WILLIAMSON COUNTY, TEXAS

CHANGE ORDER NUMBER: 2

RM 620 Phase 2 Williamson County Project No. 1608-108

Change Order No. 2

PROPOSED SIGNAL LAYOUT RM 620 AND HOSPITAL ENTRANCE

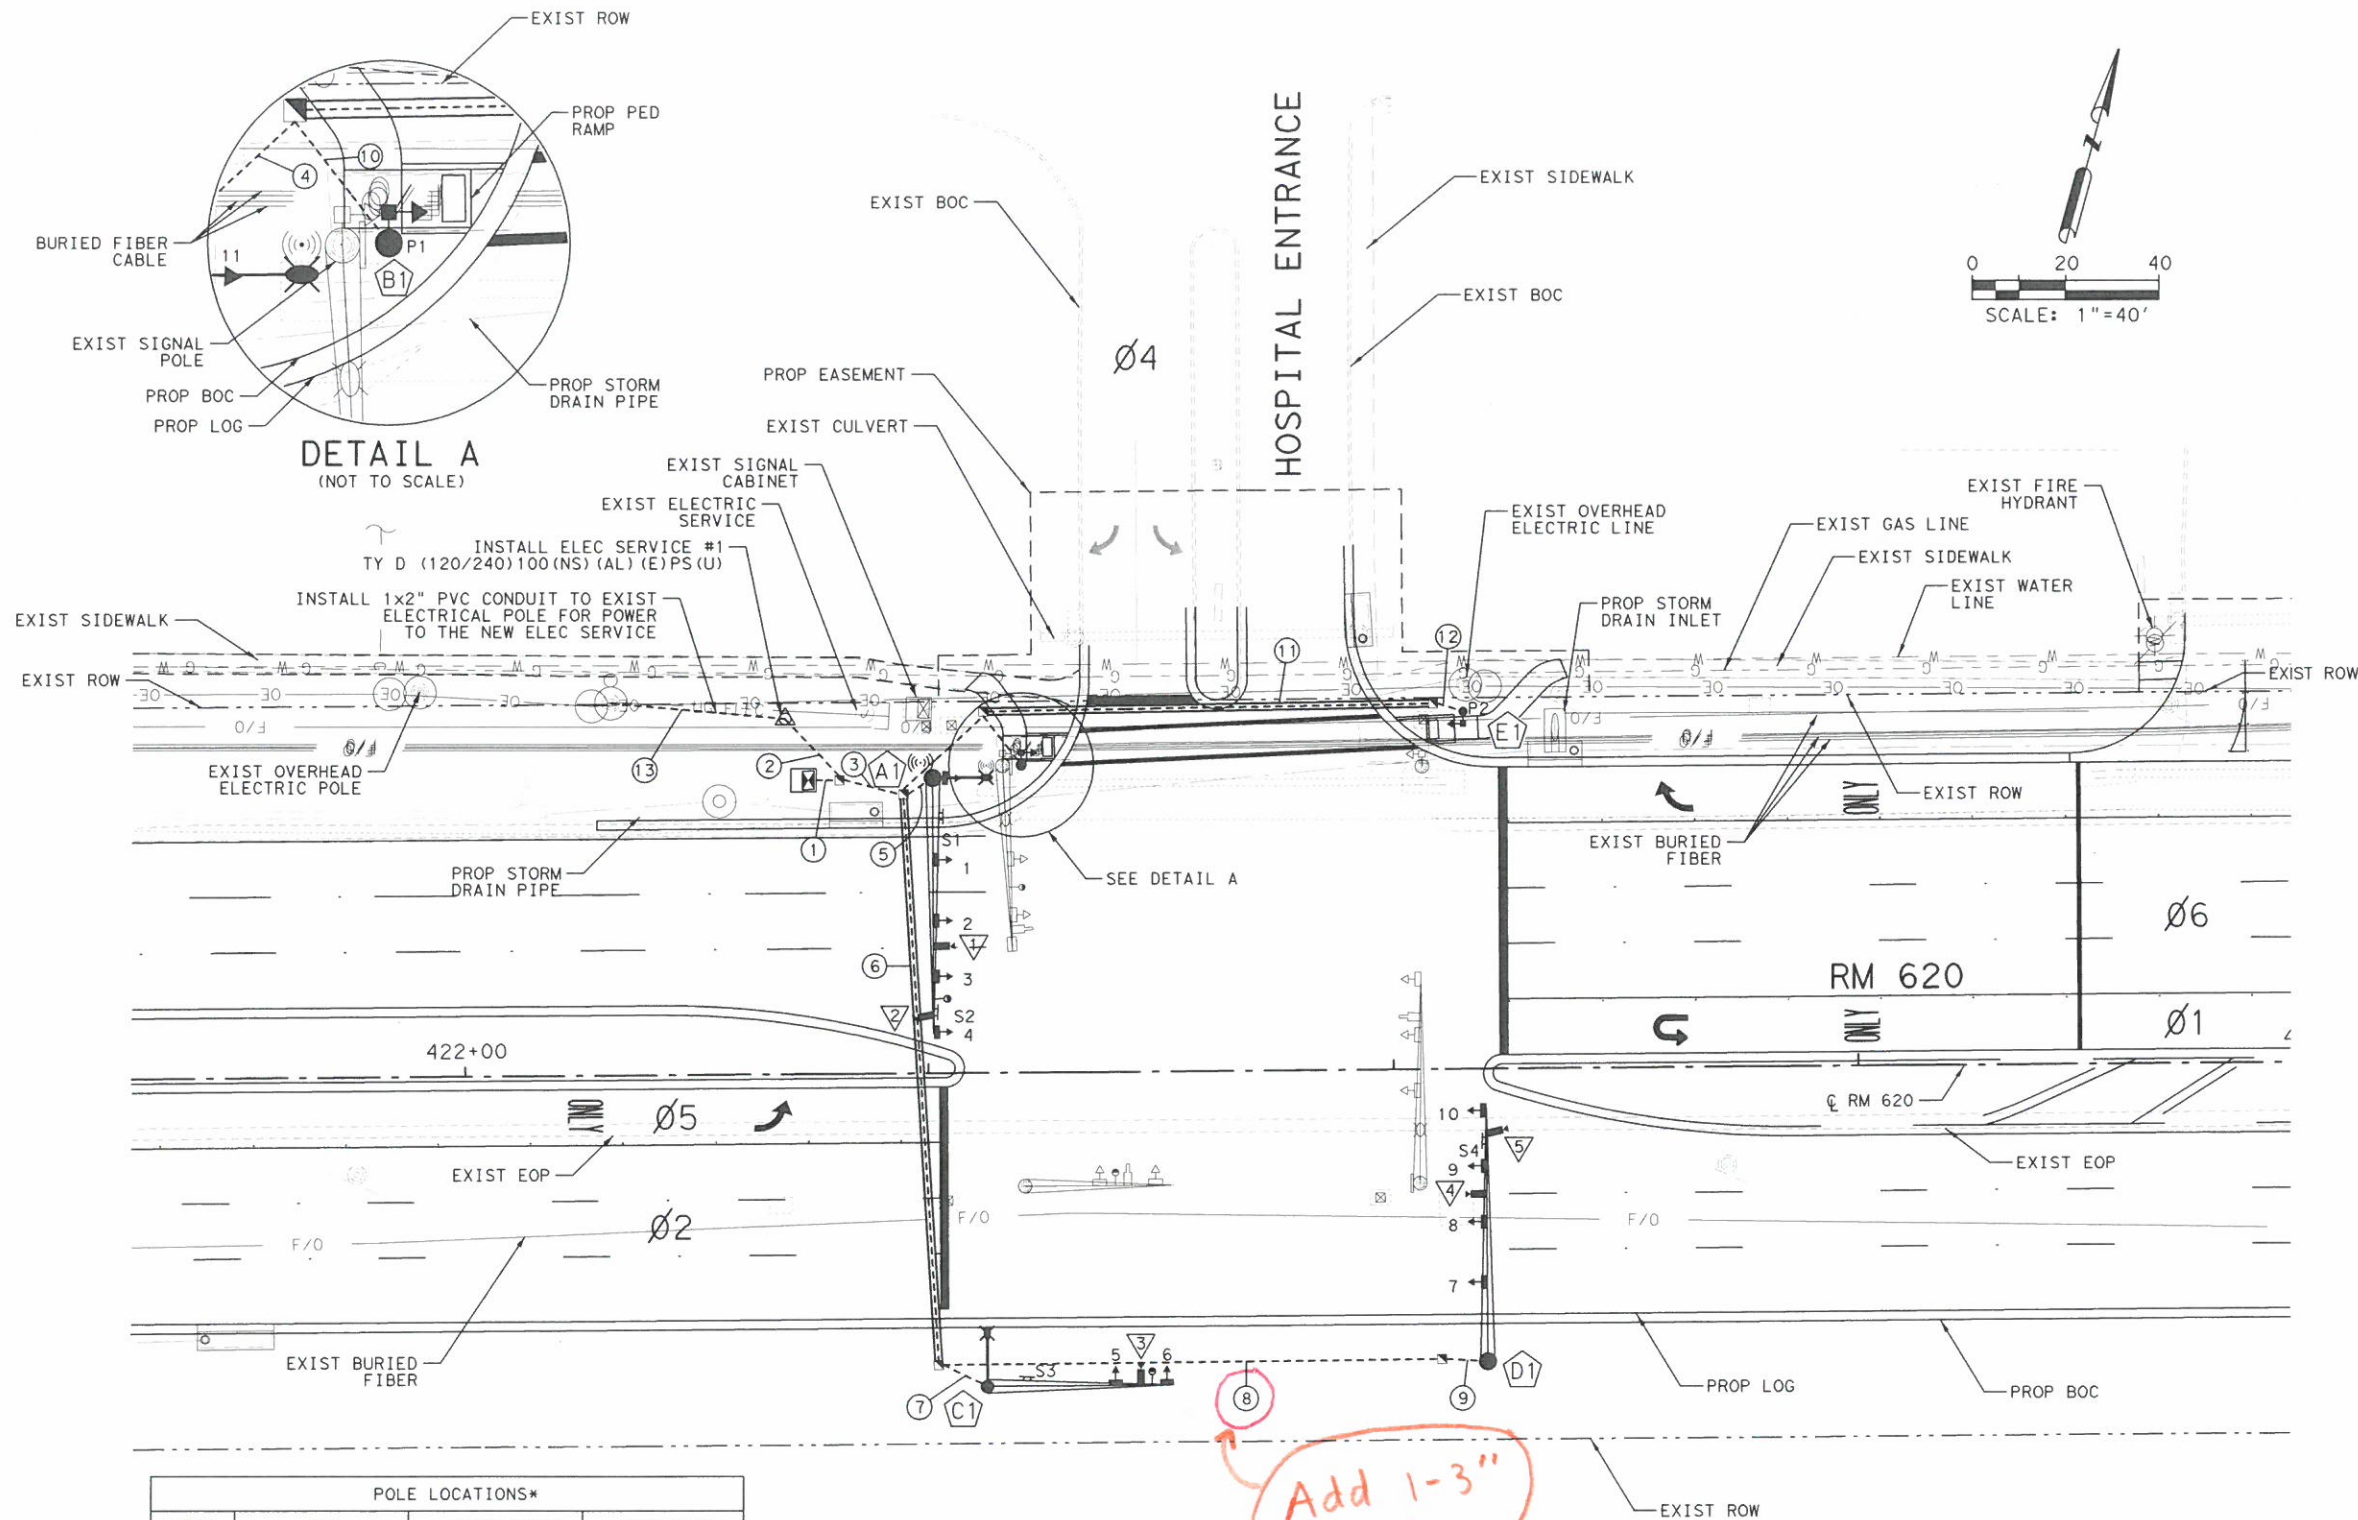
The electrical subcontractor for the Contractor (Cox Commercial) is proposing the realignment of the conduit runs at Oaklands Drive (sketch is attached). Please review & let us know if the adjustments are acceptable.

Add 1-3"
= 110'

Yes, the proposed adjustments are acceptable. The City of Round Rock also reviewed and requested additional conduit runs. See the descriptions below and also the attached redlines.

Oaklands Drive Intersection: Add one more 3" to the #15 conduit run. This would be a total of 3 - 3" & 2 - 2" conduits 125' ea. Add one more 3" conduit to the #1 run at the cabinet.

Hospital Drive Intersection: Add one 3" conduit to the #8 run.

PROPOSED SIGNAL LAYOUT
RM 620 AND OAKLANDS DR

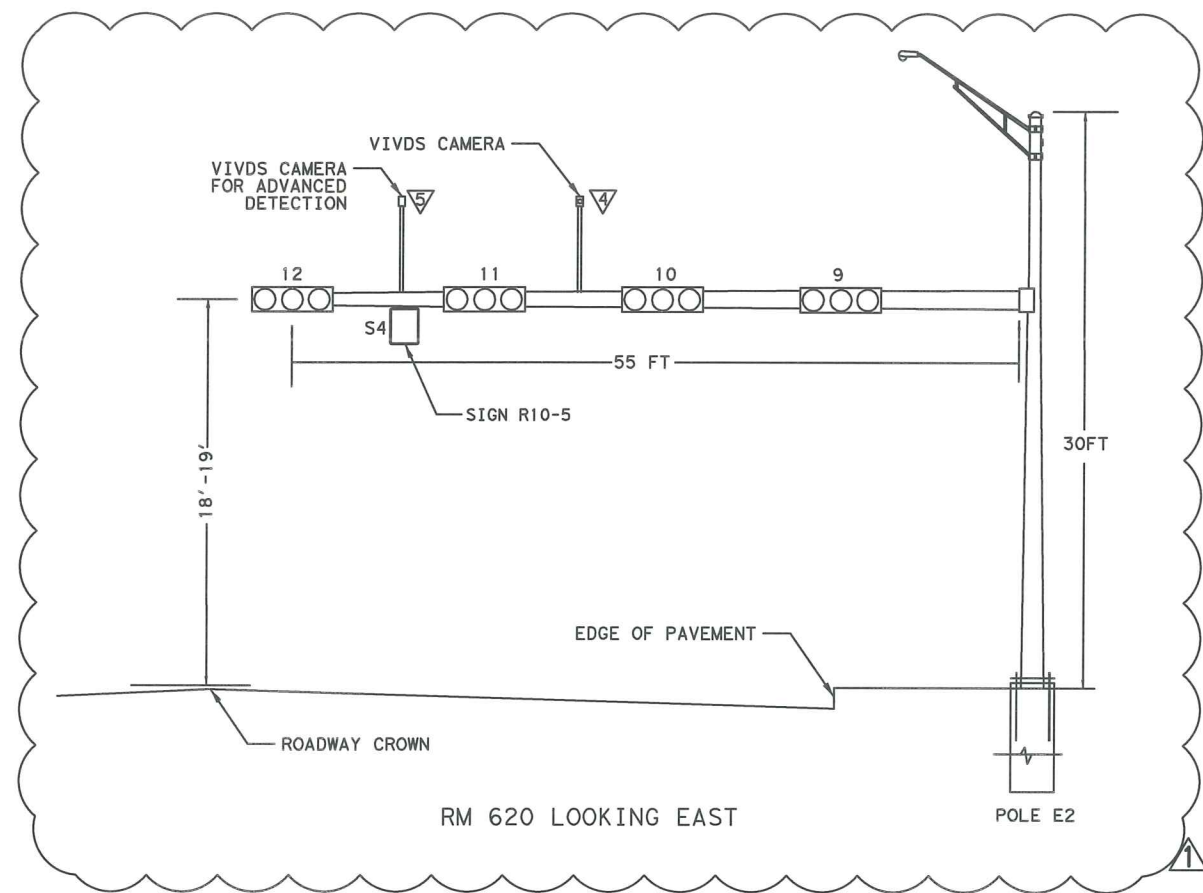
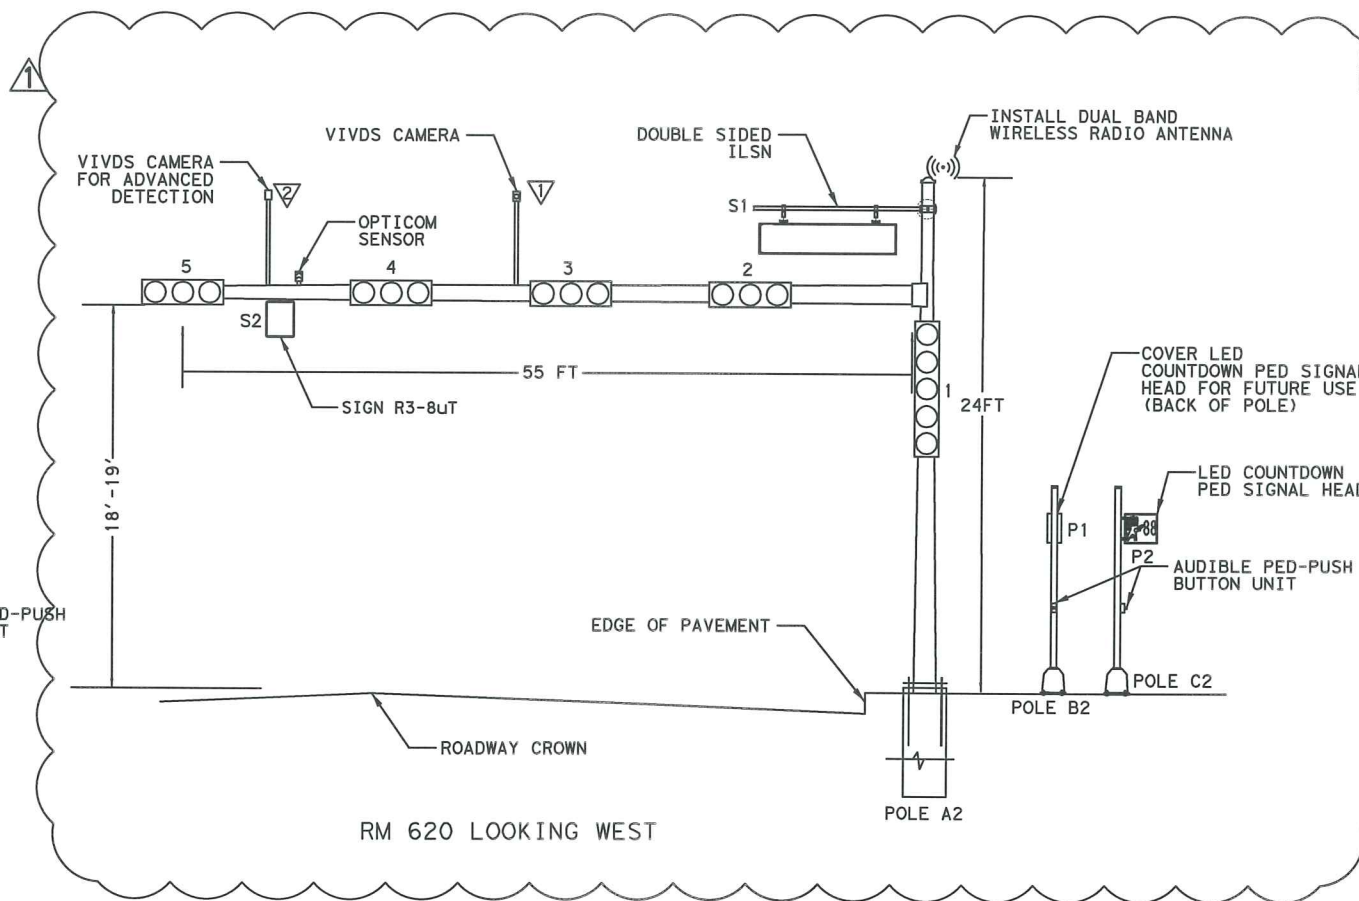
REFERENCE: RFI #8 and plan sheet 243, proposed location of signal controller/foundation.

This is in reference to previously submitted RFI #8 and plan sheet 243. The subcontractor, Austin Traffic Signal has requested to relocate the proposed signal foundation from the south east corner of the intersection to the northwest corner. The southeast corner of the intersection is crowded with temp poles, guy wires, box culvert that prevents the installation of the permanent foundation. Also in the event of service, a vehicle would not have a place to pull off of the roadway and park due to the slopes. The northwest corner would offer a flatter area to park, if not in the adjacent business parking lot. After the existing utilities were located, we have found a clear location for the controller. The proposed control foundation location is immediately west of the pole A2 on the layout.

RM 620
CURB INLET TYPE IIR

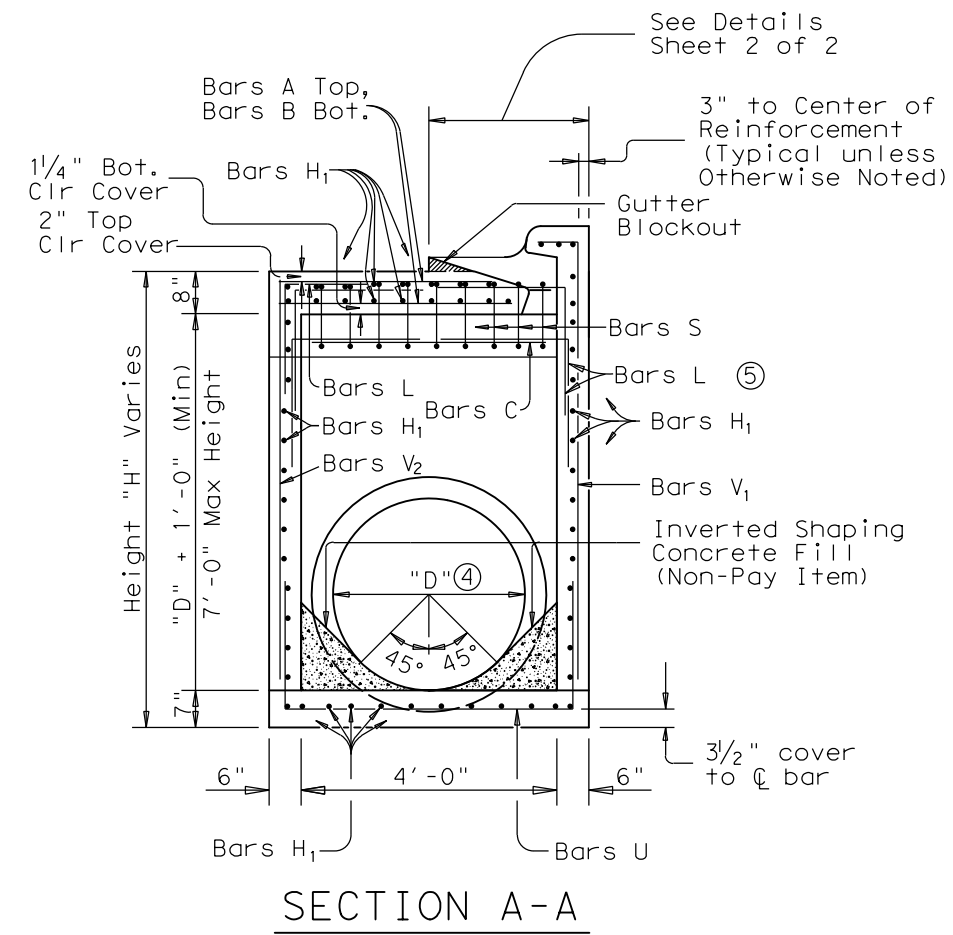
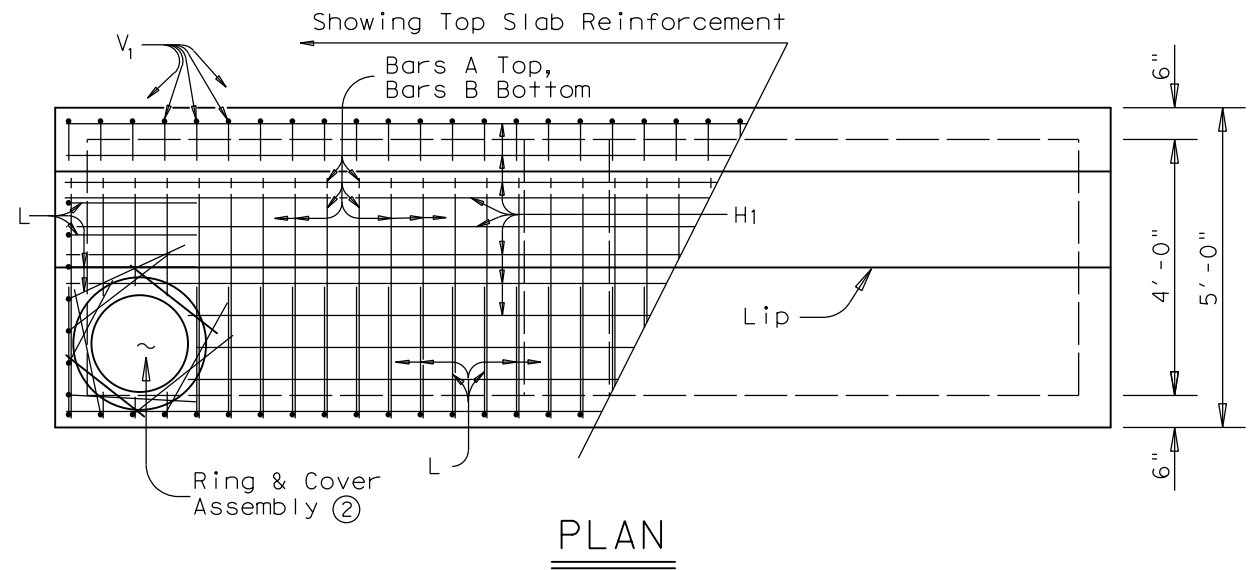
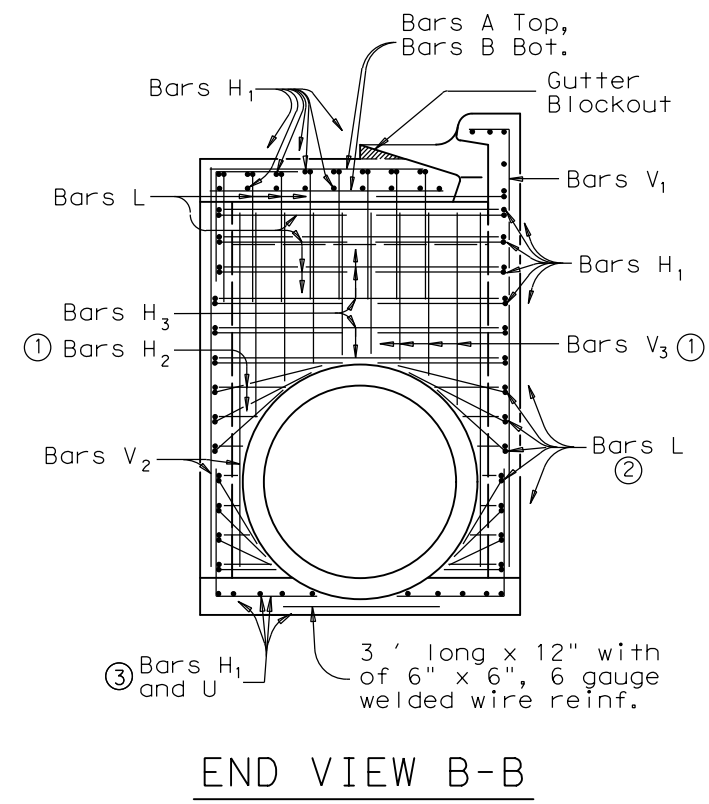
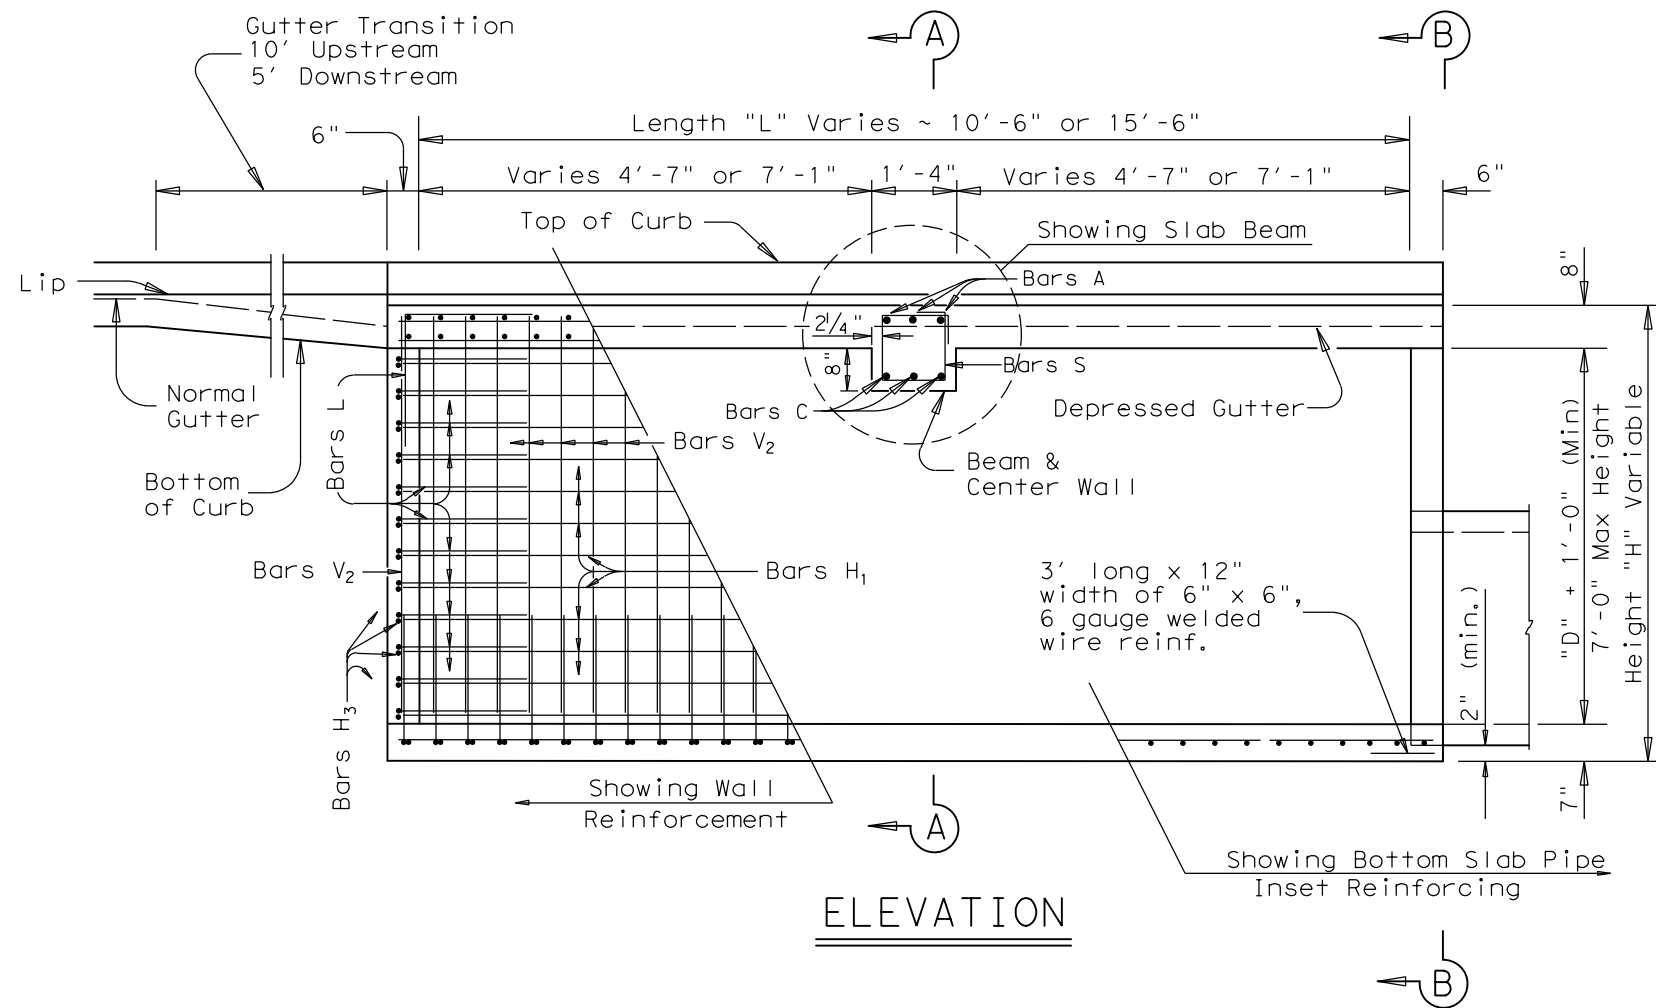
The plans show inlets C1 & C1-A to be TY IIR. A pay item does not exist for this type of inlet. Can one be established so that we may provide pricing for & bill under? Thanks.

The proposed unit rate from the Contractor of \$12,945 per EACH is accepted. The existing 465-6181 item described as "INLET (COMPL) (TYII) (15 FT)" in the Bid Tab for \$7,200/EA will be removed via Change Order and replaced with 465-WC01 described as "INLET (COMPL)(CURB)(TY IIR)(15)" for the new price of \$12,945/EA. Contractor to provide materials and construct the Type 2R inlets, per the details shown in the plans.
